**DESIGN REVIEW COMMENT SHEET**

Meeting Date: March 3, 2015 Map: 73 Lot: 41.1, 4.1.2 & 4.1.3  
 Applicant: Gladstone LP, Stuart Bornstein Zone(s): B3 and APD  
 Site Location: 690, 698 and 706 Higgins Crowell Road

The project is a proposed 228 space commercial parking lot with winter boat storage and a small guard shack on an existing vacant lot. Dan Ojala gave a brief presentation on the project. Concept is for a commercial parking lot for the ferries in Hyannis with a shuttle bus during the tourism season with boat storage in the winter. No chain link fencing for security, just a wooden split rail fence. Security cameras will be provided for security. Parking is proposed to be gravel and not paved with bioretention areas for stormwater. Parking area lighting is proposed, in addition to illumination of the free standing signage. Lights will be 20' fixture height, LED cut-off fixtures. Layout of the boats will depend on the size of the boats and a layout plan will be provided to Site Plan Review. A small septic system is proposed for the guard shack. Bus shelter will be made of wood with a wooden bench and glass sides (similar to the bus shelter in front of the State Police on Ro

PREC 3/3/15  
 CONCEPT SKETCH

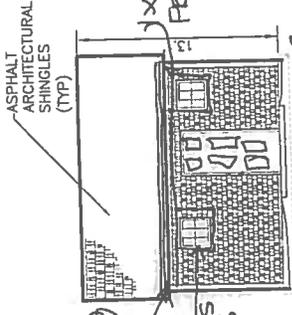
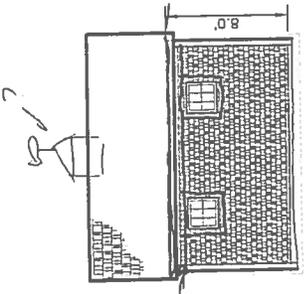
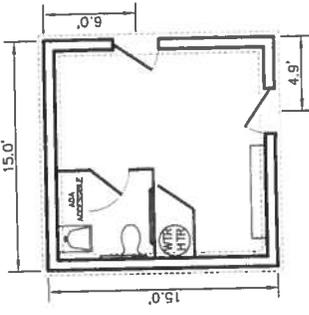
**Proposed changes to the architectural design of the guard shack include: 1x8, 1x3 rake boards, 1x6 corner boards, 1x4 trim around windows and doors, frieze board, square soffit, 1x8 fascia, 6 panel door, and simulated divided lights or grills between the glass. Refer to attached Concept Sketch.**

SOUTH ELEVATION  
 SIM. DIVIDED LT. WINDOWS OR AT THE LEAST  
 GRILLS BY GLASS

EAST ELEVATION  
 6 PANEL OR SOMETHING ELSE MORE
